19 Denmark Street Design & Access Statement - Addendum

Scheme Section

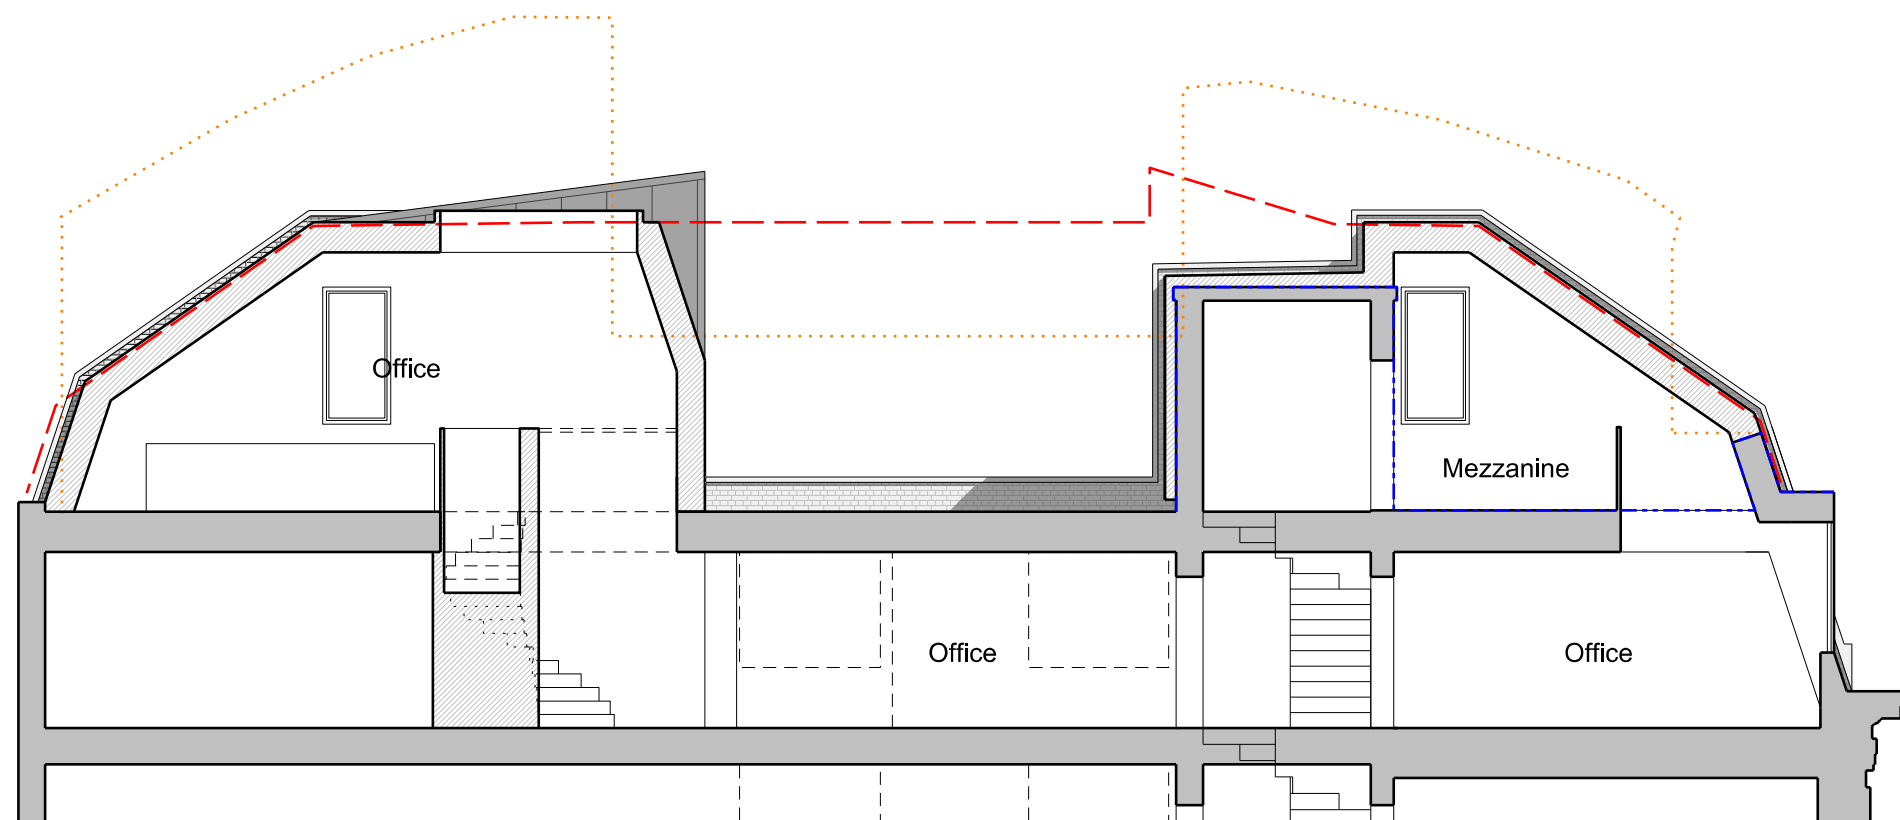
Previously Submitted Scheme

Amended Scheme

- Original roof outline
- ... Former pre-application outline
- Former planning application outline

Proposed East elevation.

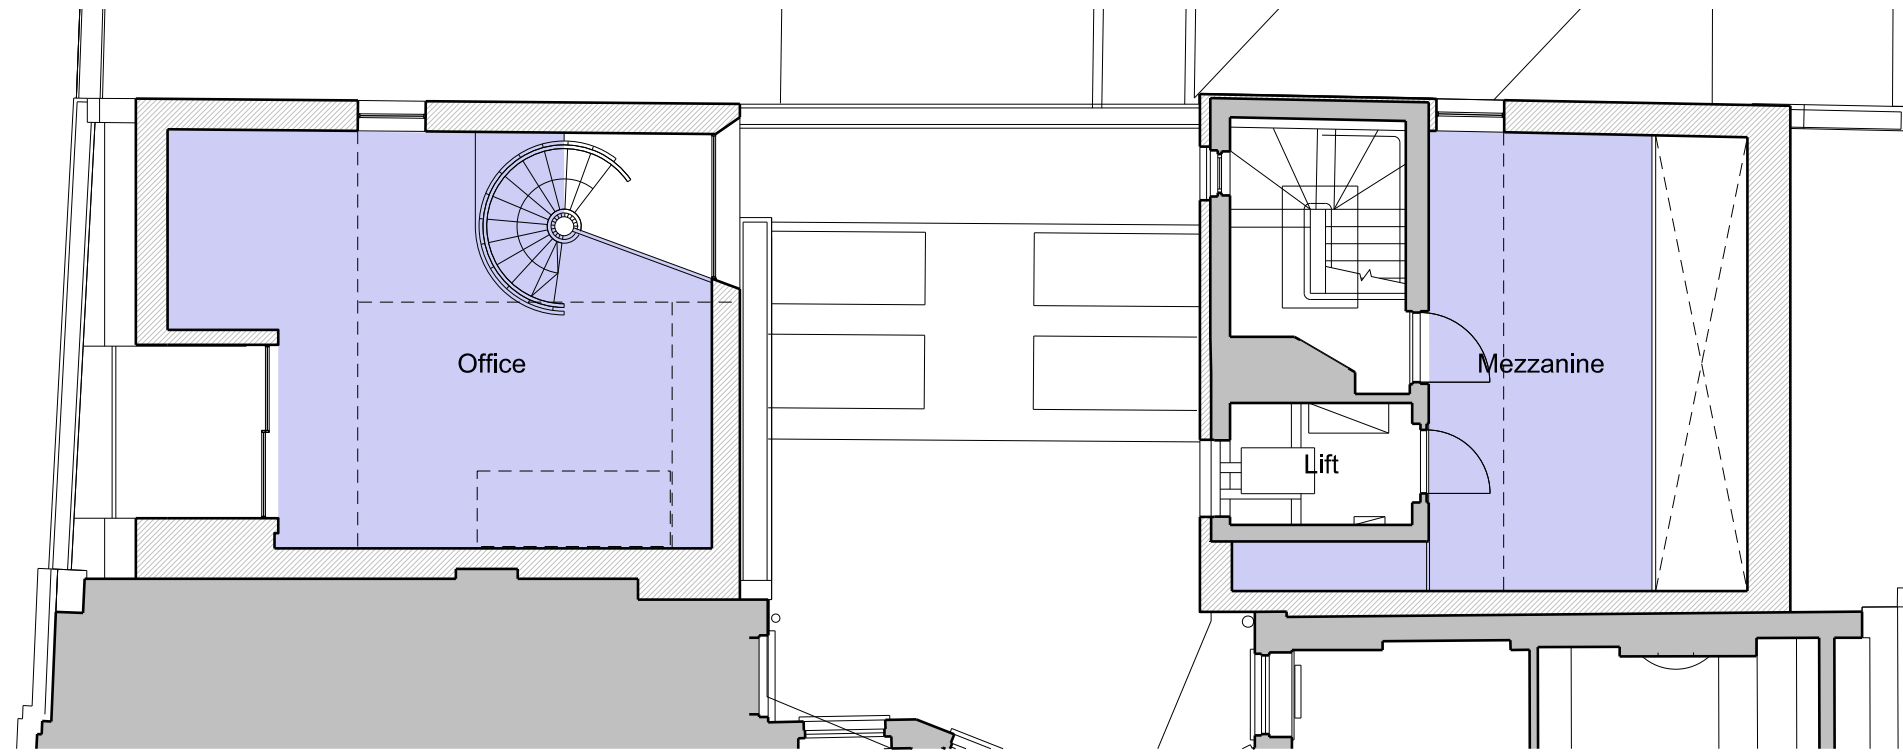
As part of this application, two gable windows are proposed to the east elevation (No.20 Denmark St.).

These windows allow access to ventilation and daylight whilst avoiding both, overlooking and excessive solar gains.
